Krav til kommende søopmåling i Frederick E Hyde Fjord – ind til Citronen Fjord

Requirements of future surveying in Frederick E Hyde Fjord - into Citronen Fjord

Skitse over opmålingsområdet.

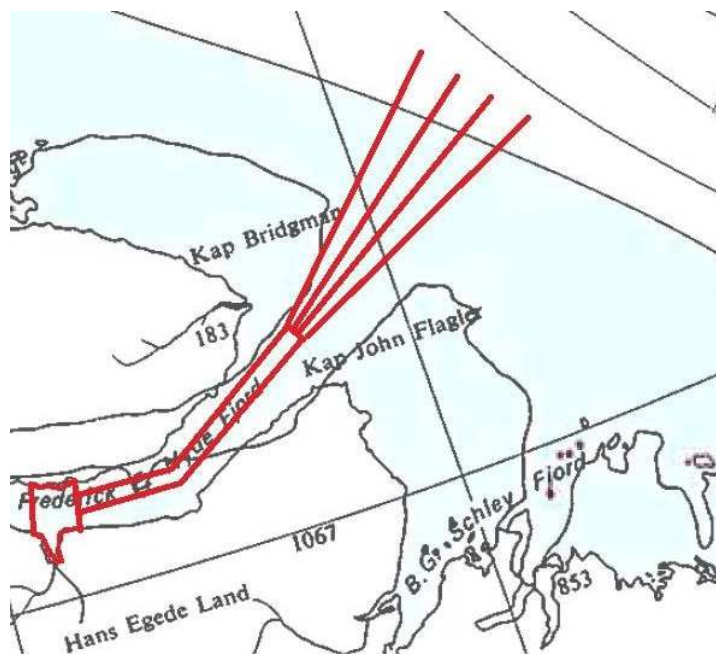
- Overordnet skal søopmålingen gennemføres til en order 2. (IHO S-44 – 5th edition) med fuld bunddækning hvor det er muligt.
- Den isfrie del af området, inklusiv Citronen Fjord, måles med flerstråleekkolod. Dette omfatter som minimum den del af FEHF, der strækker sig fra Citronen Fjord og øst over indtil opmåling med flerstråleekkolod ikke længere er mulig pga. isforekomst. Den del af FEHF, der strækker sig 2 sm vest og 4 sm øst af Citronen Fjordens munding, opmåles indtil 50 m dybdekuren. I den øvrige isfrie del af FEHF mod øst måles en korridor med en minimumsbredde på 3 sm.

- I områder med isforekomst, der umuliggør søopmåling med flerstråleekkolod, kan opmålingen foretages med enkeltstråleekkolod, idet der fortsat måles en korridor på 3 sm.

- I tilfælde af opmåling med enkeltstråleekkolod, i områder med dybder større end 100 m, skal afstanden mellem de enkelte opmålingslinjer være højst 100 m. I områder med dybder mindre end 100 m, skal der måles med en linieafstand på højst 50 m.

- Såfremt der i enkeltstråleopmålingen konstateres kritiske dybder – eller indikationer herpå, skal der foretages afsøgning for bestemmelse af den mindste dybde.
- I opmålingsområdet opstilles vandstandsmålere med en afstand på 20 km. Vandstandsmålerne opsamler data i opmålingsperioden og helst i en periode på samlet 30 dage. (Kravet til vandstandsmålere kan evt. nedjusteres såfremt isforholdene umuliggør opstilling af vandstandsmåler.)
- Fra munden af fjorden måles i tragtform 4 singlebeamlinier ud til 500 m dybdekurven, således at der på 500 m dybdekurven dækkes en bue på ca. 15 sm. De opsamlede rekognosceringslinier vil blive anvendt af SFS og GST til vurdering af evt. yderligere opmåling. Hvis der er mulighed for opsamling af flerstråleekkolodsdata bør der om muligt måles en korridor ud til 200 m konturen.

Såfremt der måtte kontraheres med isbryder udrustet med flerstråleekkolod, vil det skitserede område kunne måles med flerstråleekkolod og der vil kunne ses bort fra de krav, der ovenfor er stillet til enkeltstråleekkolod.

Outline of the survey area

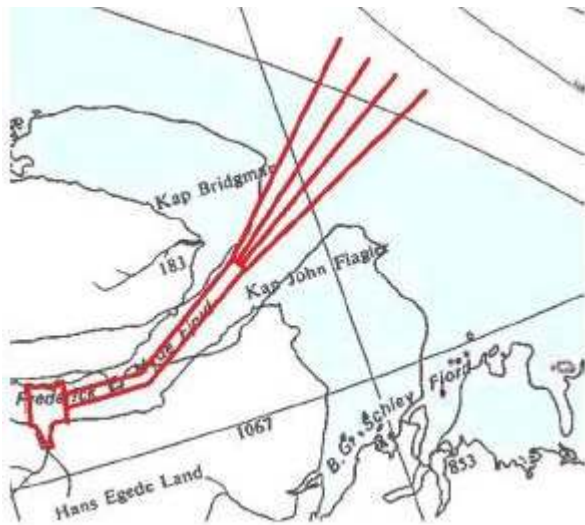
- In general, the survey must be conducted as an 'Order 2' (IHO S-44 - 5th edition) with a full bottom coverage where possible.
- The ice-free part of the area, including Citronen Fjord, is to be measured with multibeam echo sounder. As a minimum, this includes the part of FEHF that goes eastwards from Citronen Fjord until measurement with multibeam echo sounder is no longer possible due to ice. The part of FEHF that stretches 2 NM west and 4 NM east of the entrance to Citronen Fjord is to be measured within the 50 m isobath. In the remaining ice-free part of FEHF towards east, a corridor with a minimum width of 3 NM is to be measured.

- In areas of naturally occurring ice that prevents surveying with multibeam echo sounder, measurements can be carried out by use of single beam echo sounder, while continuing to measure a corridor of 3 NM.

- When measuring with single beam echo sounder in areas with depths greater than 100 m, the distance between the measurement lines should not exceed 100 m. In areas with depths less than 100 m, the distance between the measurement lines should not exceed 50 m.

- If, during single beam survey, critical depths are found - or indications to that effect, exploration must be carried out in order to determine the lowest depth.
- Tide gauges are placed in the survey area at a distance of 20 km. The tide gauges collect data in the survey period, preferably for a period totalling 30 days. (The required number of tide gauges may be reduced if ice conditions make it impossible to install the tide gauges.)
- From the mouth of the fjord, four single beam lines in a funnel shape are measured to the 500 m isobath, thus covering an arc of approx. 15 NM at the 500 m isobath. The reconnaissance lines collected will be used by DMA and DGA to assess any additional surveying. If it is possible to collect multibeam echo sounder data, a corridor to the 200 m contour should be measured.

If an icebreaker equipped with multibeam echo sounder is contracted, the outlined area could be measured with multibeam echo sounder, and the requirements above relating to single beam surveying may be disregarded.
